Access Compliance Report

Public Rights-of-Way

Intersection ID: 16819	Main Street: SOUTHSIDE_DR	Cross Street: OLD_PINEVILLE_RD	Location: NW
ADA ID: 659DB3391ACF	Ramp Type: Perpendicular Diagonal	Initial Pass/Fail: Fail	Overall Compliance: No
		Severity Score: 12.5

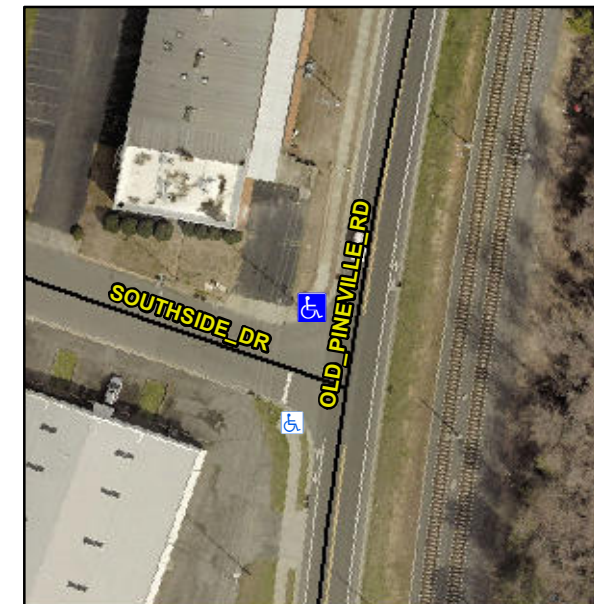
Not Found, R304.5.3

Compliance	Description	Data	Compliance	Description	Data
N/A	Ramp Length (in)	36.0	Yes	Ramp Slope (%)	7.0
Yes	Ramp Width (in)	48.0	No	Ramp XSlope (%)	5.2
N/A	Flare Type LT	N/A	N/A	Flare Type RT	N/A
N/A	Flare Slope LT (%)	N/A	N/A	Flare Slope RT (%)	N/A
N/A	Flare Traversable LT?	N/A	N/A	Flare Traversable RT?	N/A
N/A	Landing Length (in)	N/A	N/A	DWS Provided?	N/A
N/A	Landing Width (in)	N/A	N/A	DWS Contrast?	N/A
N/A	Landing Slope (%)	N/A	N/A	DWS Length (in)	N/A
N/A	Landing X Slope (%)	N/A	N/A	DWS Full Width?	N/A
N/A	Landing Curb? (Y/N)	N/A	N/A	DWS Offset (in)	N/A
N/A	Shared Landing?	N/A			
N/A	Gutter Ponding?	N/A	N/A	Gutter Slope (%)	N/A
N/A	Gutter Lip Ht (in)	N/A	N/A	Gutter X Slope (%)	N/A
N/A	Painted X Walk1?	No	N/A	Painted X Walk2?	No
	X Walk 1 Direction	To SW		X Walk 2 Direction	To E
N/A	X Walk 1 Width (in)	N/A	N/A	X Walk 2 Width (in)	N/A
	X Walk 1 Slope (%)	0.1		X Walk 2 Slope (%)	0.5
	X Walk 1 X Slope (%)	2.1		X Walk 2 X Slope (%)	0.5

Remove & Replace Curb Ramp With Two New Directional Ramps or Equivalent.
